Service Bulletin

Category G	Applicable Model/s '95-'97 Millenia	Subject GRINDING NOISE DURING ENGINE CRANKING	Bulletin No.	002/97
			Issued	04/25/97
			Revised

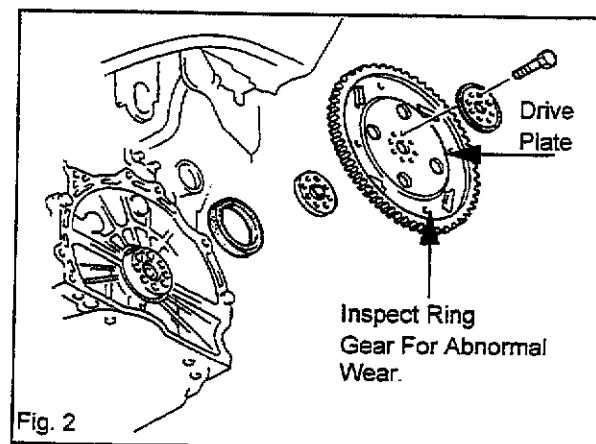
1. Remove the under cover from the transmission as shown in Fig. 1.

2. Inspect ring gear
 - If worn, proceed to step 3.
 - If not worn, inspect related parts for noise source.

3. Replace drive plate and starter.

NOTE: The starter must be replaced because the pinion is possibly damaged.
